From: Clara Turlington
Sent: 25 September 2008 10:33
To: 'clive.carey@gmail.com'
Subject: RE: Application at Burton House NYM/2008/0594/LB and NYM/2008/593/FL

Amended Plans Burton House NYM/2008/0594/LB and NYM/2008/593/FL
Notes

Re : Burton House, Robin Hoods Bay

Appendix C - Roof Plan of proposed front elevation

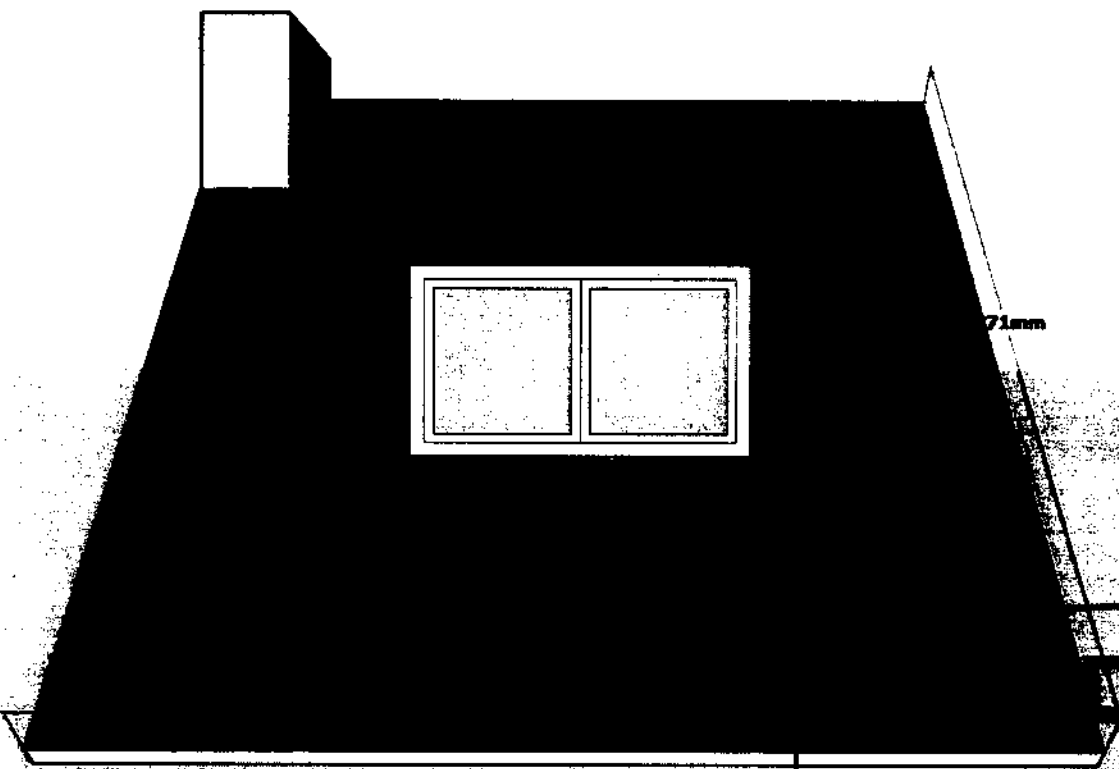
Due to the objections by the planning officer I have omitted the velux from the updated plans I sent to you and for the avoidance of doubt I am also therefore removing it from my overall planning application. The planning application as it stands only contains the proposed changes to the dormer window including changes requested by the planning officer.

Additionally, and at the request of the National Park, the roof tiles will handmade clay and the window, while keeping the same outer dimensions, will be changed to included two equal sized panes with a central mullion so that the fenestration is similar to the adjoining property as can be seen in appendix C above.
